Executive Director's Recommendation

Commission Meeting: July 10, 2025

PROJECT Capital One Arena Improvements 601 F Street, NW Washington, DC	NCPC FILE NUMBER 8617
	NCPC MAP FILE NUMBER 21.10(38.00)46006
SUBMITTED BY District of Columbia Office of the Deputy Mayor for Planning and Economic Development	APPLICANT'S REQUEST Approval of preliminary site and building plans
REVIEW AUTHORITY District Projects in the Central Area per 40 U.S.C. § 8722(b)(1) and (e)	PROPOSED ACTION Approve preliminary site and building plans
	ACTION ITEM TYPE Staff Presentation

Lighting Plan

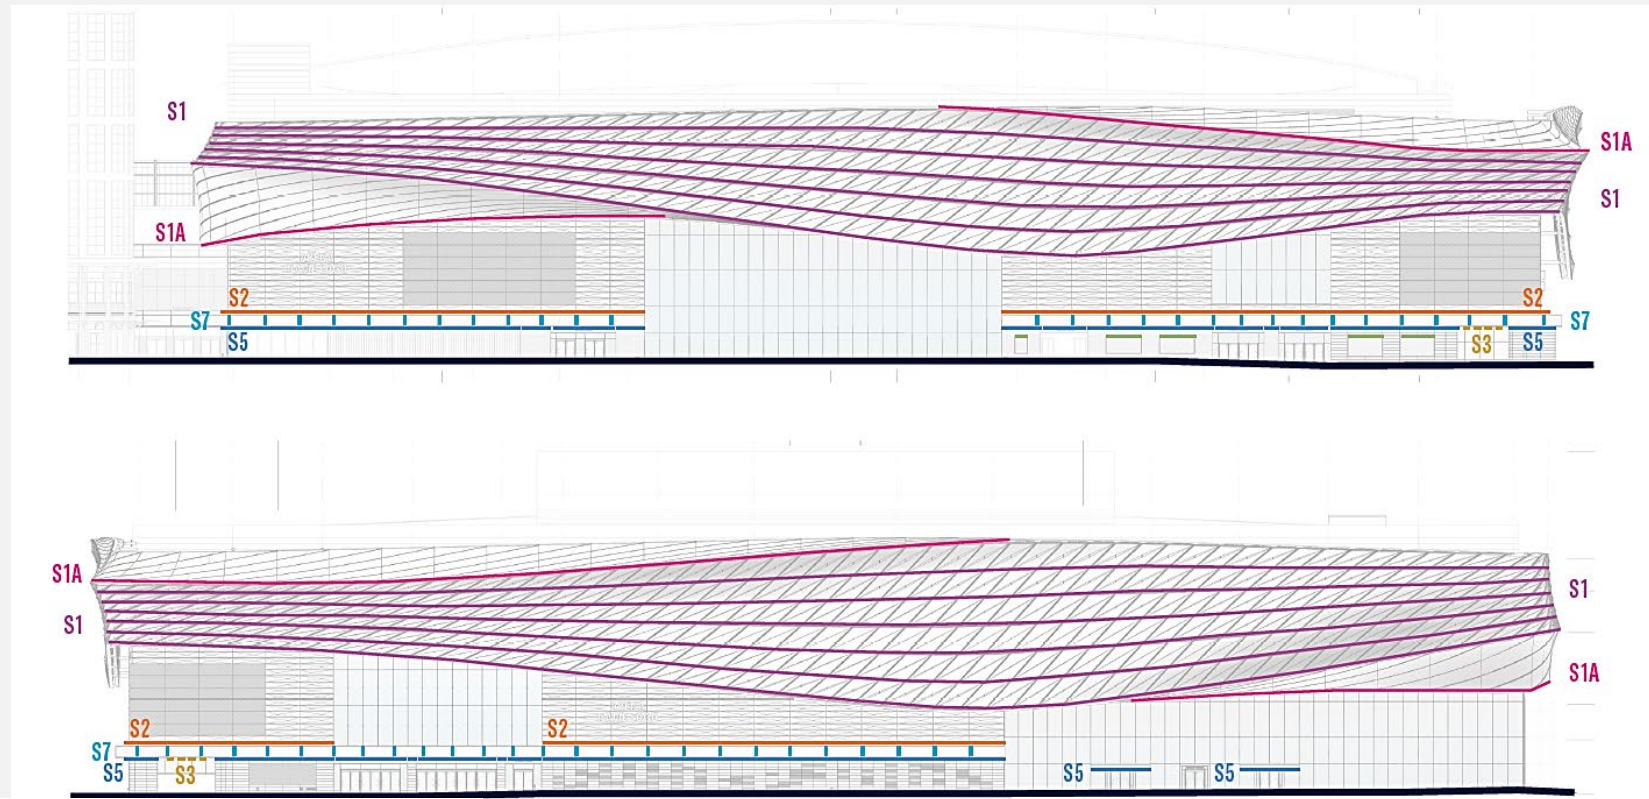
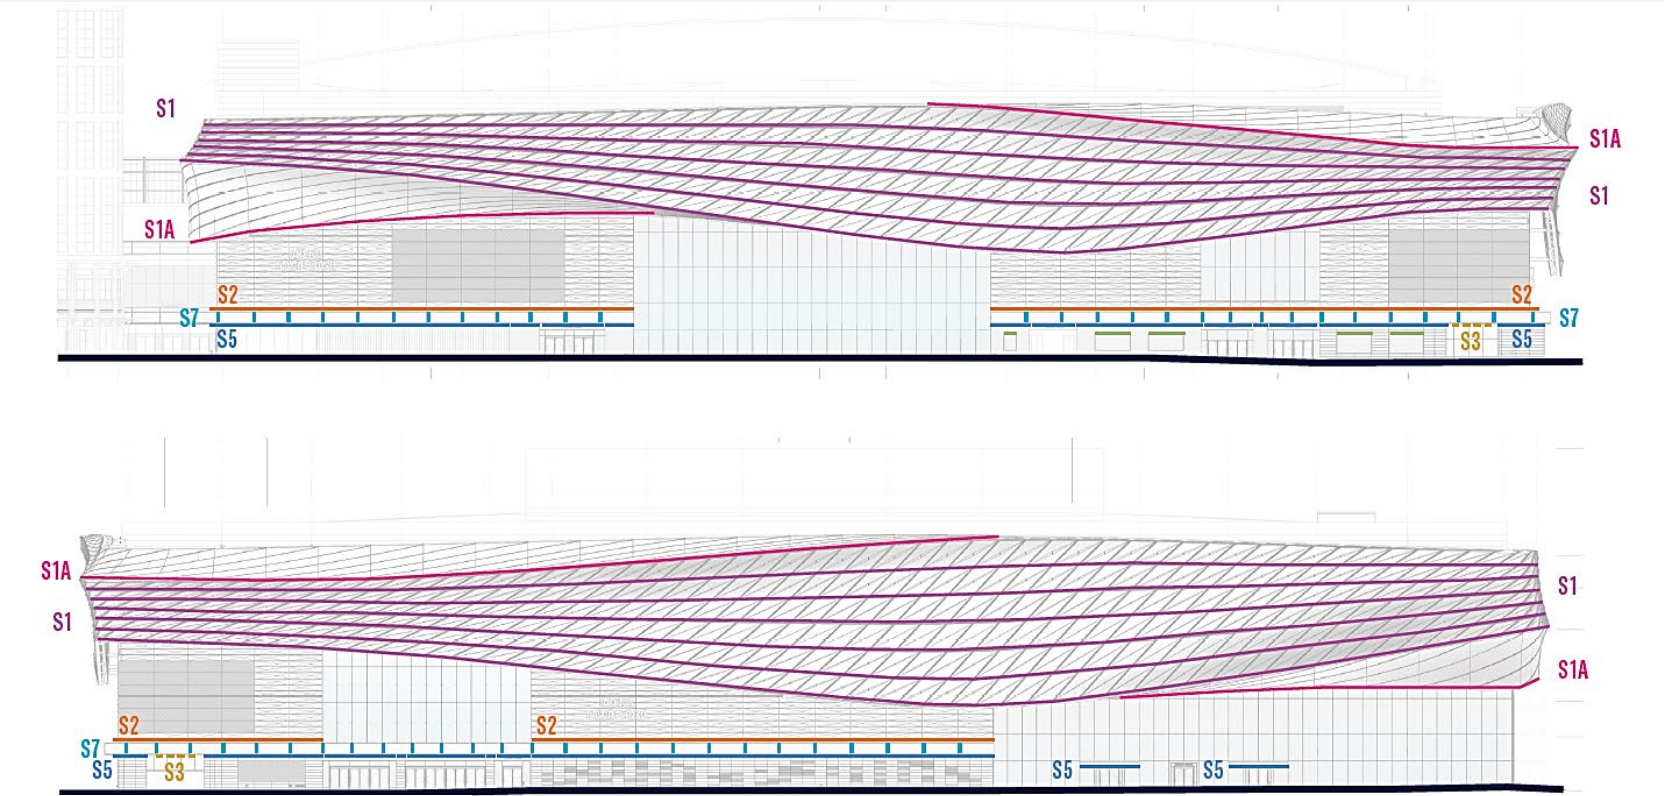
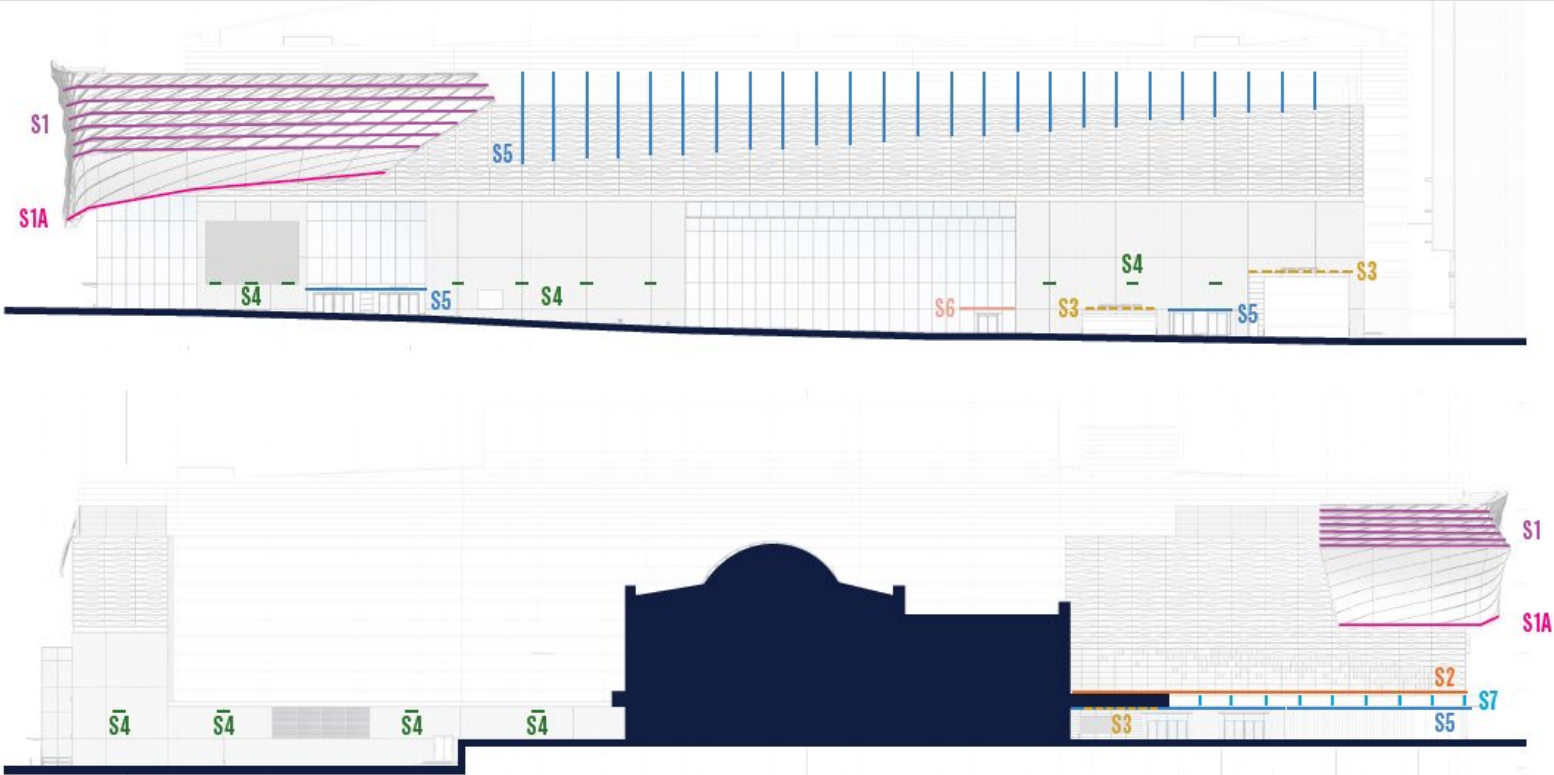
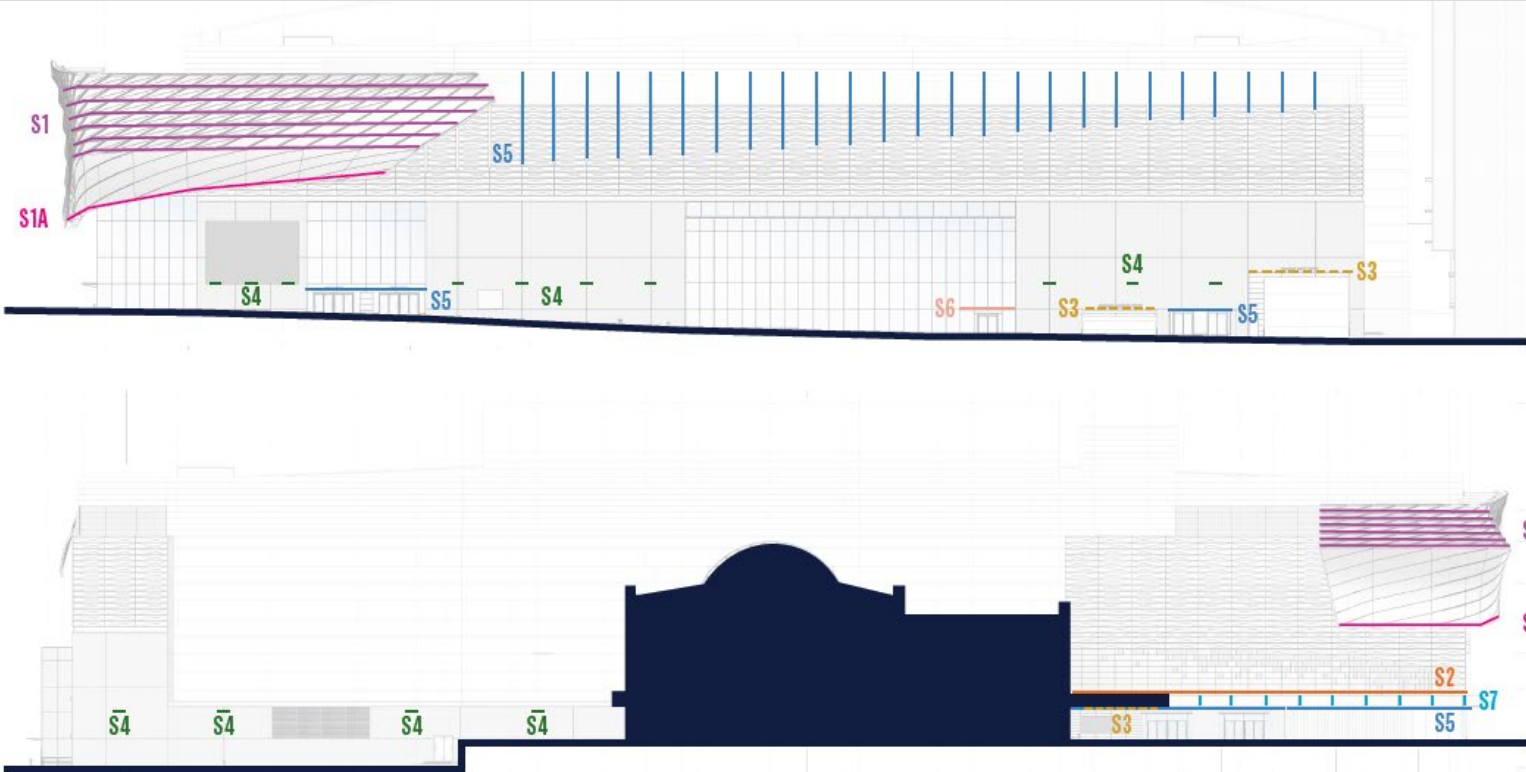
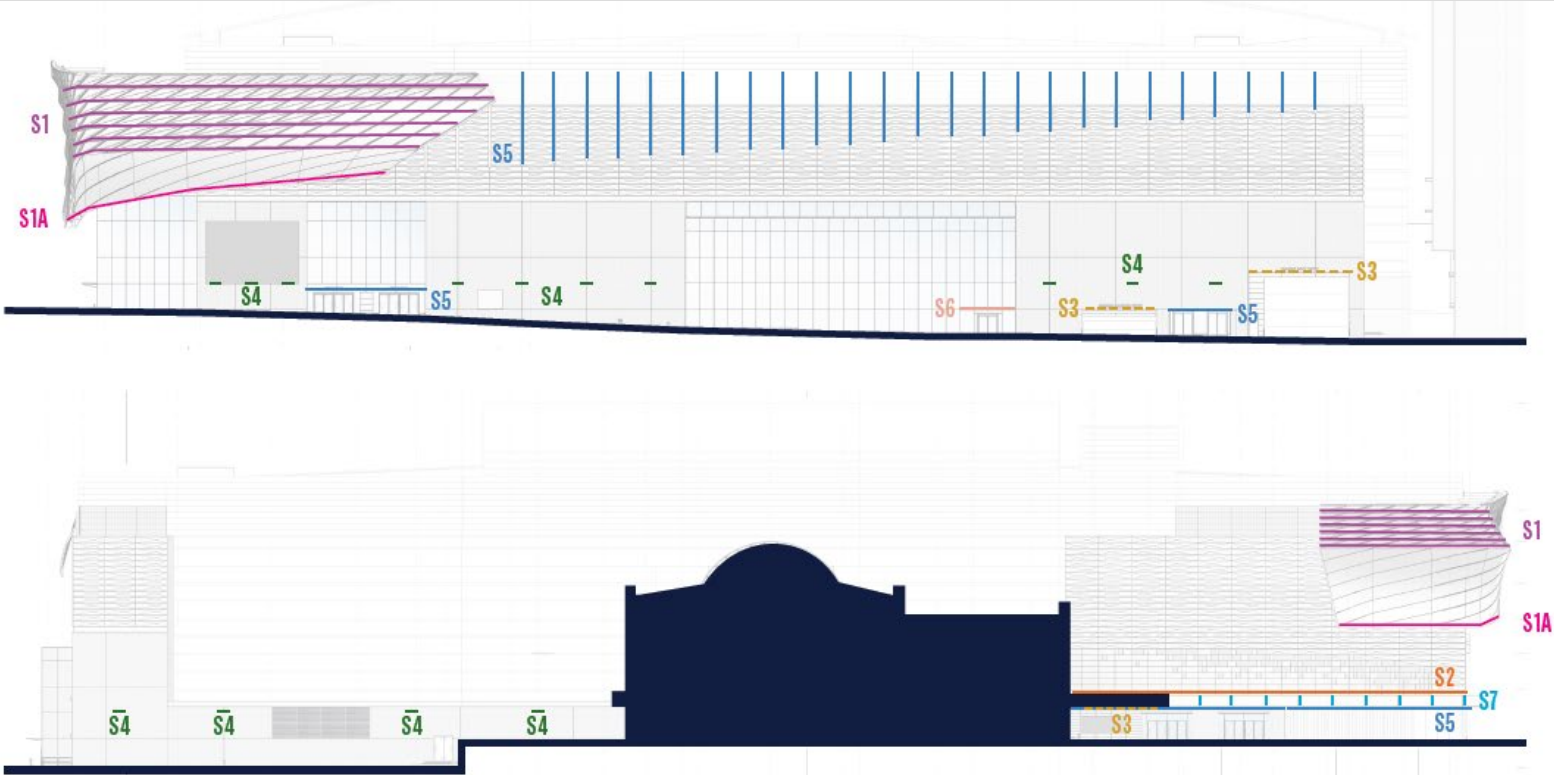
Recommends the applicant continue to refine the lighting plan to demonstrate the intended illumination levels and aesthetic for the combined lighting on the updated building.

106 Memorandum of Agreement (MOA). Specifically, no portion of the exterior digital displays or veil will be illuminated prior to 6 am or after midnight or 30 minutes after an event at the arena, whichever is later. Further, the brightness of the digital display boards and veil will be substantially reduced after sundown until the time both are required to be turned off. Finally, during the time when the digital display boards and veil are required to be turned off, any lighting of the arena's building façades will be maintained only at the level that is required to meet applicable public safety requirements. The applicant has also supplied the specific lighting fixtures and technical details of the lighting. As the plans are finalized, staff suggests the **Commission recommend the applicant continue to refine the lighting plan to demonstrate the intended illumination levels and aesthetic for the combined lighting on the updated building.**
